**June 2010 DRAFT - FOURTH EXPLANATION OF SIGNIFICANT DIFFERENCES
FOR USE OF A LOWER HARBOR CAD CELL
NEW BEDFORD HARBOR SUPERFUND SITE
OPERABLE UNIT #1
NEW BEDFORD, MASSACHUSETTS**

D. Summary of Proposed ESD

This fourth ESD for ROD 2 modifies the upper and lower harbor remedy to include the construction and use of a confined aquatic disposal (CAD) cell in the lower harbor for disposal of approximately 300,000 cy of mechanically dredged sediments with PCB levels above the ROD 2 action levels.¹ The volume of *in situ* sediments to be placed in this lower harbor CAD cell (LHCC) shall not be greater than the volume of *in situ* sediments slated for CDF D (approximately 725,000 cy) minus the volume of *in situ* sediments disposed or to be disposed offsite pursuant to the 2002 ESD (approximately 150,000 cy as of 6/1/10). See further discussion in Section II.C below. This ESD also notes that, based on an assessment of sediment volume performed in 2003, and including an allowance for over-dredging, the total *in situ* sediment volume above the ROD 2 action levels is currently estimated to be approximately 900,000 cy.

**Figure 1 -
state-approved
area for
navigational
CAD cells**

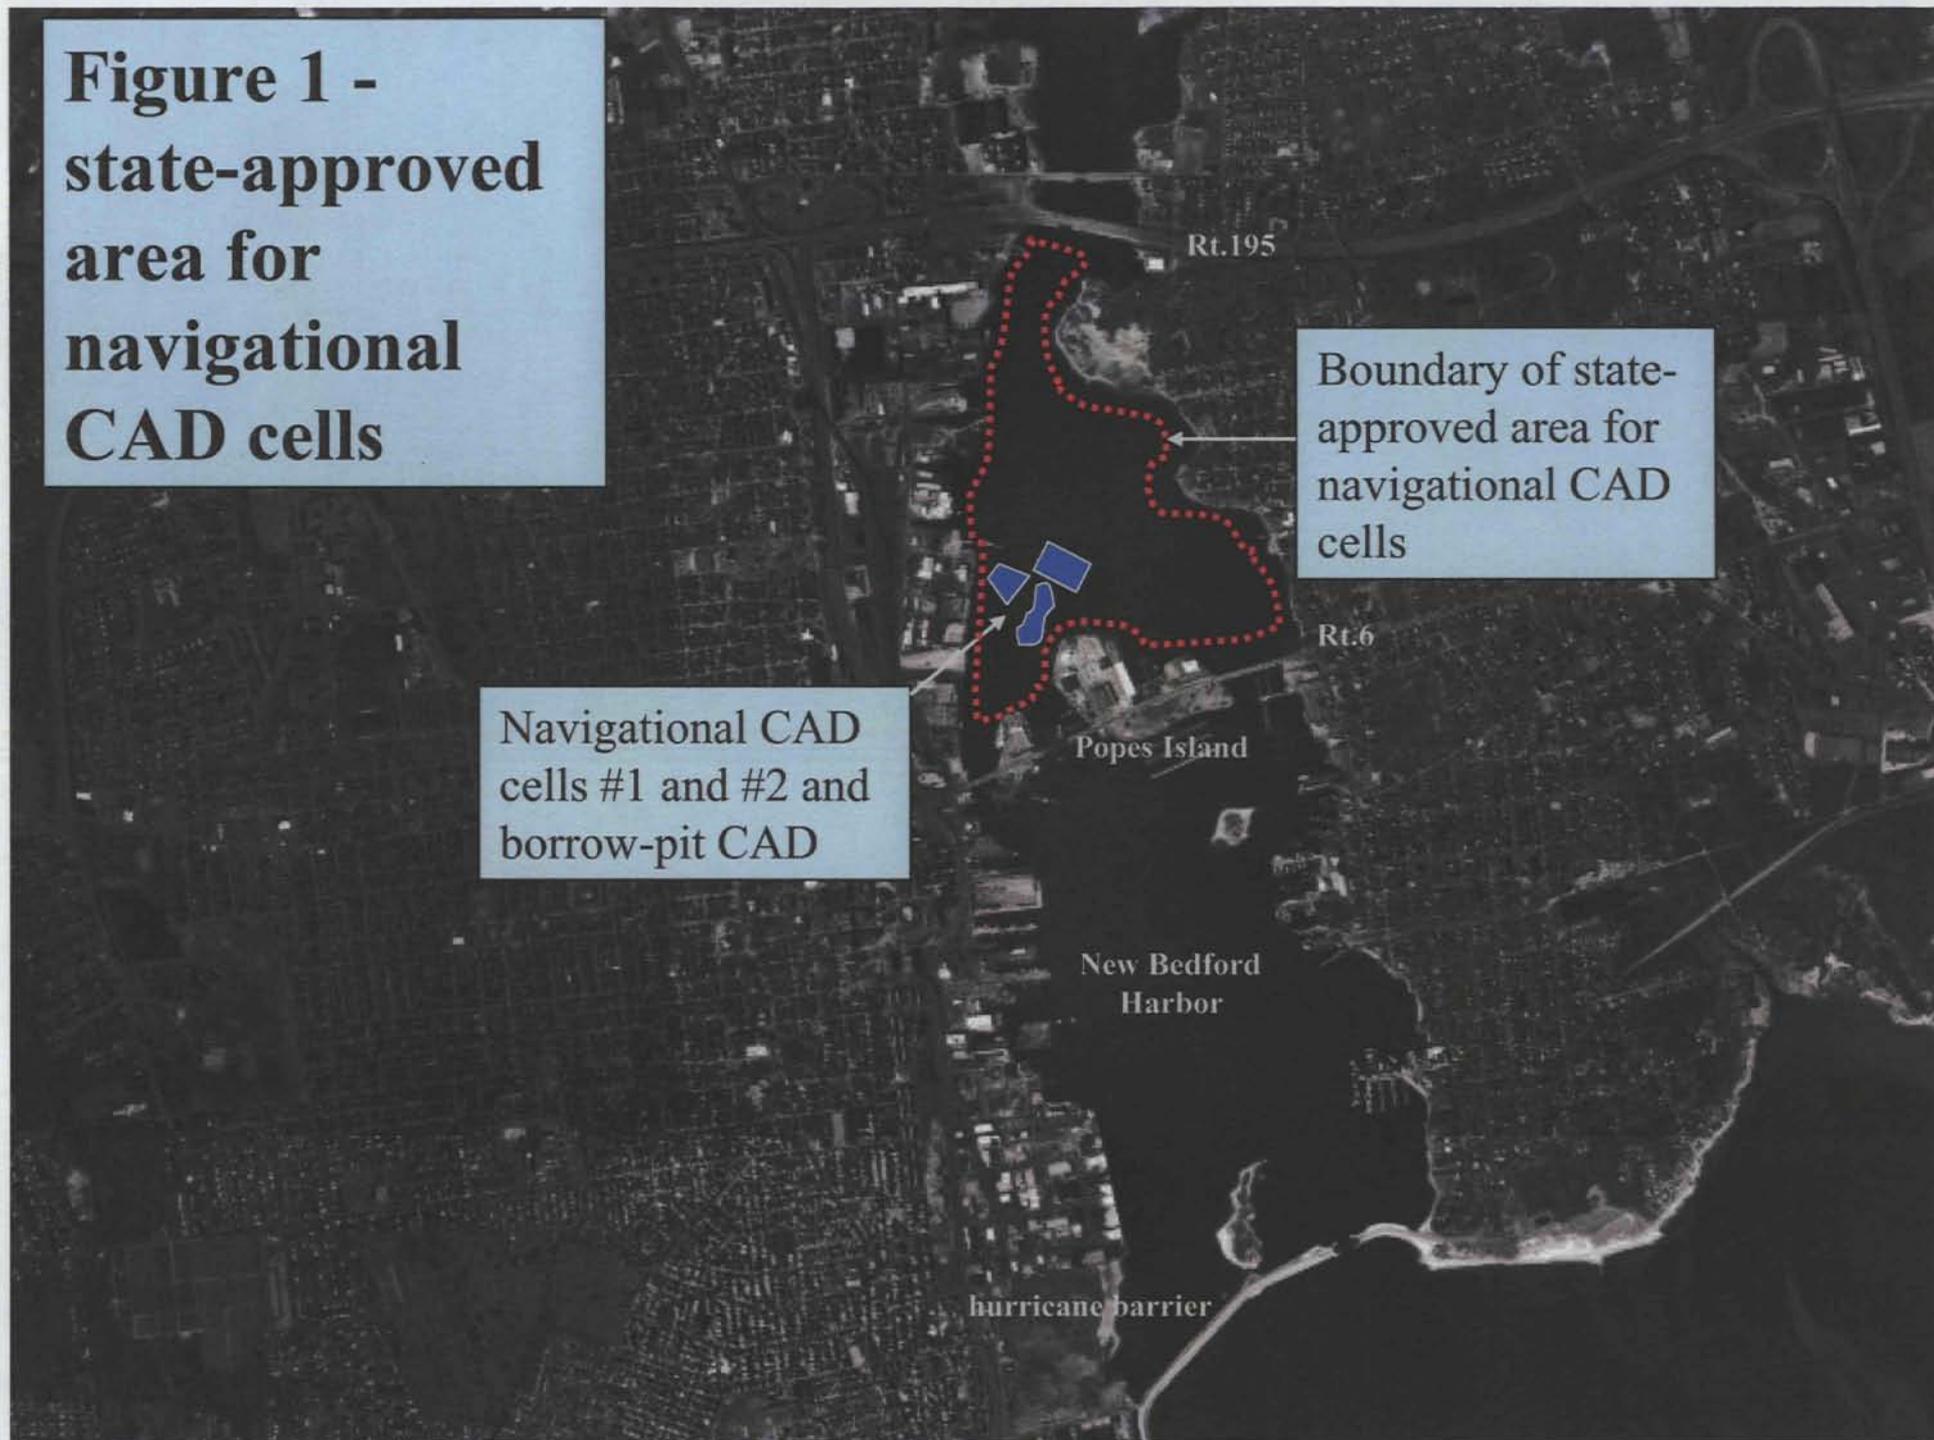
The preferred location for navigational CAD cells in New Bedford (between the Route 195 and Route 6 bridges) was determined in the October 2003 final Environmental Impact Report (FEIR) for the New Bedford/Fairhaven Harbor Dredge Material Management Plan (DMMP) prepared by the Massachusetts Office of Coastal Zone Management (MassCZM, 2003). The FEIR, prepared to comply with the Massachusetts Environmental Protection Act and its implementing regulations (G. L. c. 30, ss. 61-62H; 301 CMR 11.00) concluded that this area, referred to as “Popes Island North” was the preferred location for CAD cells due to, among other factors, its greater depth to bedrock and thus higher disposal capacity, its location outside of main navigational channels, its lower potential for cap disruption, and its higher potential for benthic recolonization (FEIR, pp. 4-15 – 4-17). Subsequent to the FEIR, the exact boundary of the DMMP CAD cell area has been modified twice, in January 2005 and April 2008, but remains bounded by the Route 195 bridge to the north and the Route 6 bridge to the south (Figure 1). EPA, after reviewing the FEIR and additional site information, proposes to locate the Superfund LHCC within this state-approved DMMP area.

3. Siting of the proposed Superfund CAD cell north of Pope's Island is based on an extensive review by the State of potential CAD sites in NBH, which included public involvement.

Figure 2 - Turbidity Measured Inside and Outside of CAD Cell #2 - 2009

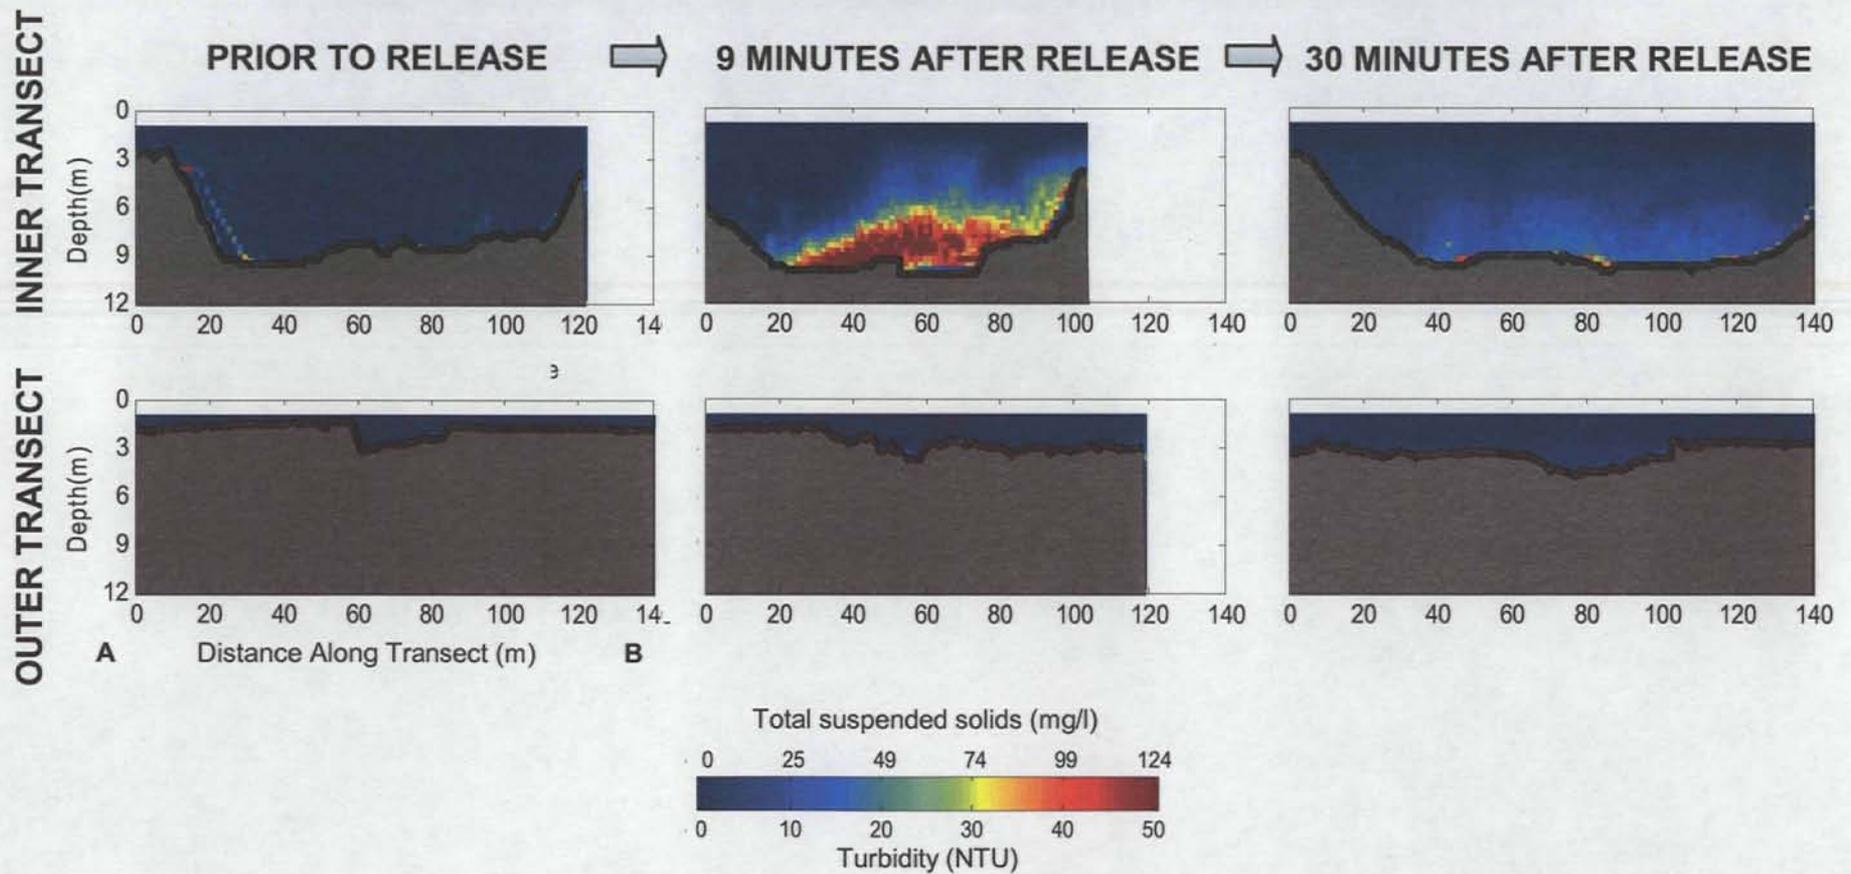
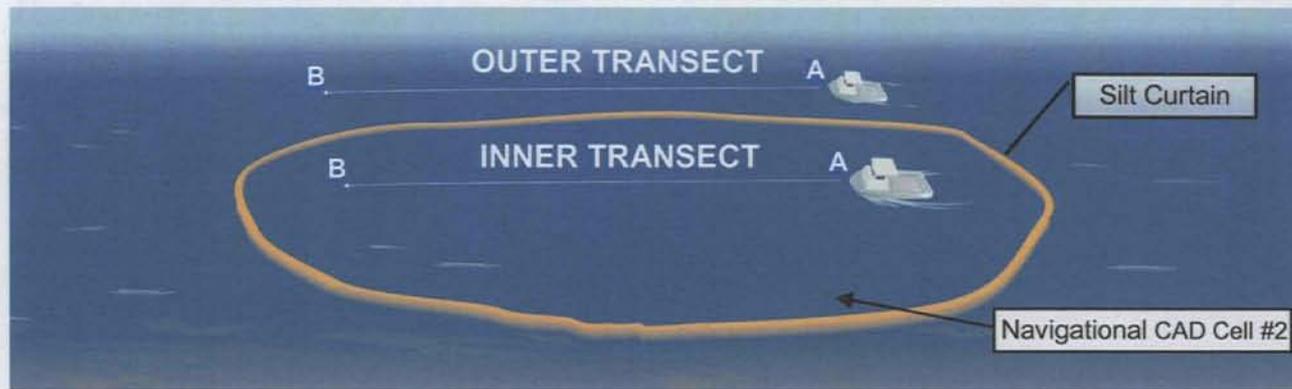
The most recent phase of navigational dredging in 2009 included CAD cell disposal of sediments dredged from areas in close proximity and with physical characteristics similar to areas slated for Superfund dredging. EPA therefore commissioned extensive water quality monitoring of the navigational CAD cell disposal process to document the efficacy of the operation (Battelle, 2009). In summary, this monitoring did not detect any acute or sub-lethal aquatic toxicity inside or outside of the CAD cell (CAD cell #2) during placement and found that the silt curtain around the CAD cell was successful in containing plumes of turbidity from the placement activities. Only small filaments of turbidity in close proximity to the silt curtain were detected, likely escaping from a seam in the silt curtain. Plumes inside the CAD cell were found to dissipate to near background levels within 1 to 1-1/2 hours. The reader is encouraged to review the report, available at <http://epa.gov/ne/nbh/pdfs/299744.pdf>, since many color-coded “snapshots” over time of these turbidity plumes are included. One of these snap-shots is included herein as Figure 2.
